Next-Page Sequence for EEE

Mario Traeber

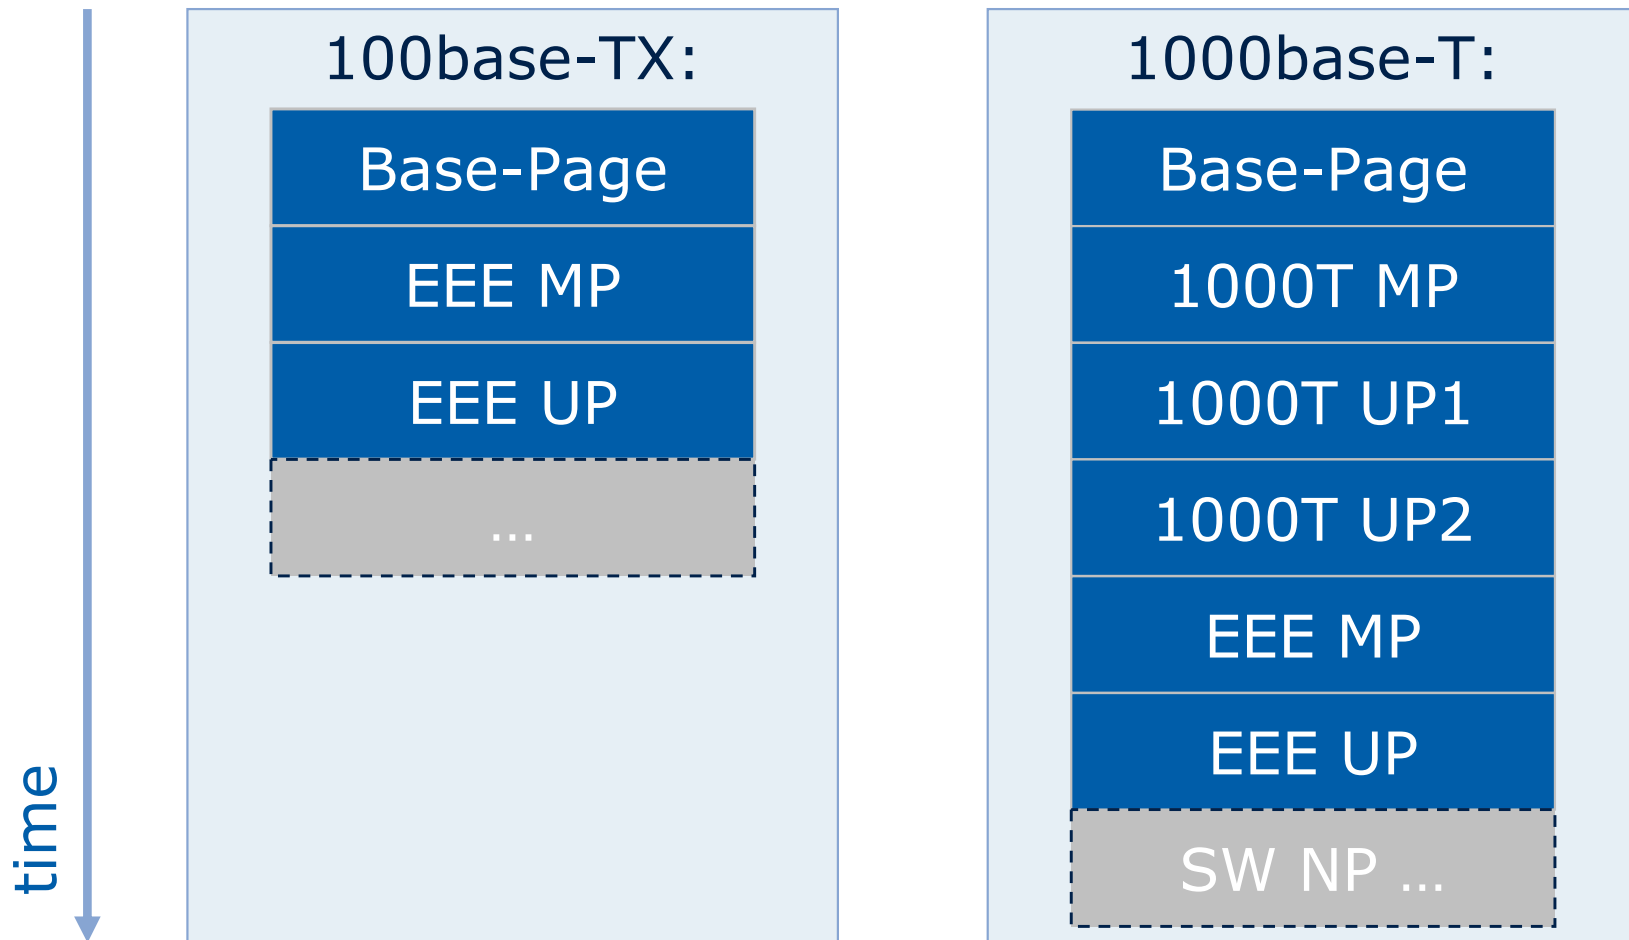
- Since clause 40 Next-Pages became mandatory.
- Within clause 40 (Annex40C) the ordering of the Next-Pages have been defined
- Within clause 40 (Annex40C) the mandatory clause 40 relevant Next-Pages must be sent autonomously
- In the current Draft 2.0 additional Next-Pages have been defined to advertize the EEE features
- However, it is not yet defined in which order they must be sent in addition to the existing PHY Next-Pages.
- Especially legacy PHYs like 100base-TX did not require any Next-Pages up to now which will change
- Existing tests will fail (see also UNH ANEG Test-Suite)
